Village of Gouverneur
Wilson and Smith Street Collection System Improvements
Project No. 2021-083

Addendum No. 1
April 1, 2025

GRAVITY SEWER CLEANOUT DETAIL

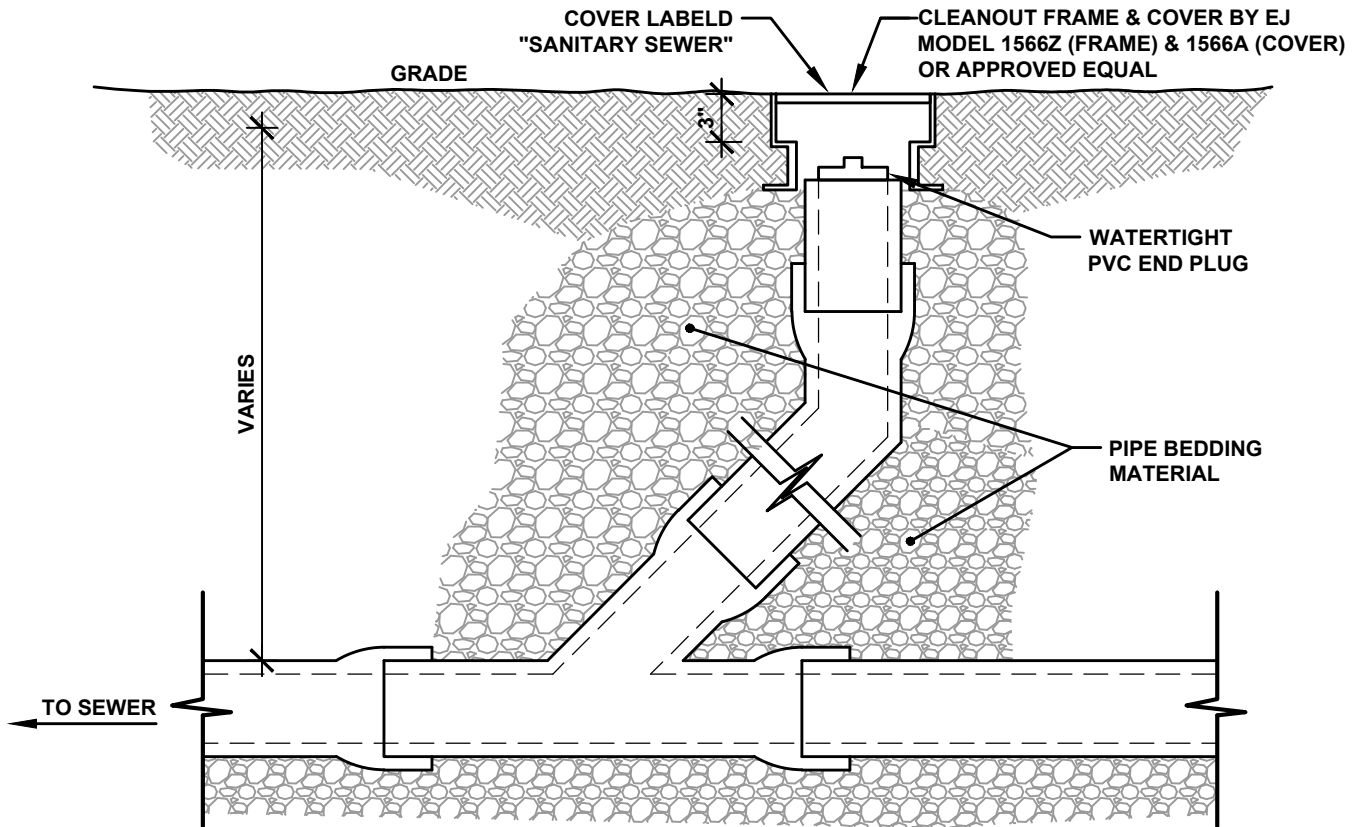
1. **Reference Sheet D-1:**
 - A. **INSERT** the attached AD1-1 gravity sewer cleanout detail in its entirety.

NOTE:
 FITTINGS FOR CLEANOUT SHALL BE
 SUITABLE FOR PIPE MATERIAL USED.
